# KP32 Loss of Audio and Boot Download Failures

## CS3310 Modifications

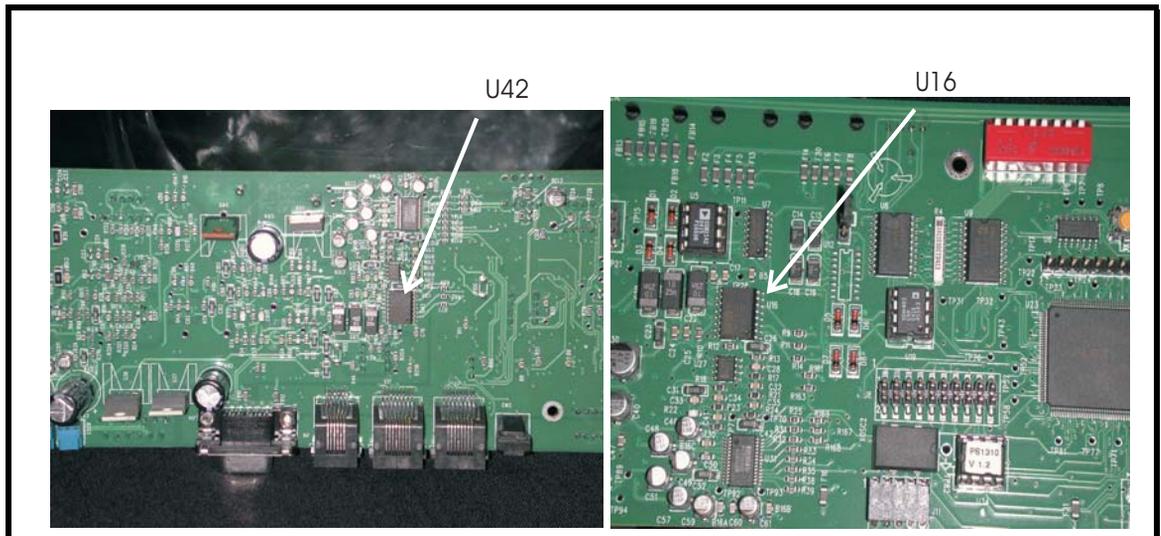
**ISSUE:** Loss of audio and boot download failures.

- Locate components U16 and U42 (see above) on the 9030-7656-001 KP-32 board.
  - If U16 and U42 are TI part **PGA2311U**, they need to be replaced with **CS3310-KS**.
  - The Telex part number for the CS3310-KS is 5110720-000.
  - For factory replacement of the ICs, please contact:
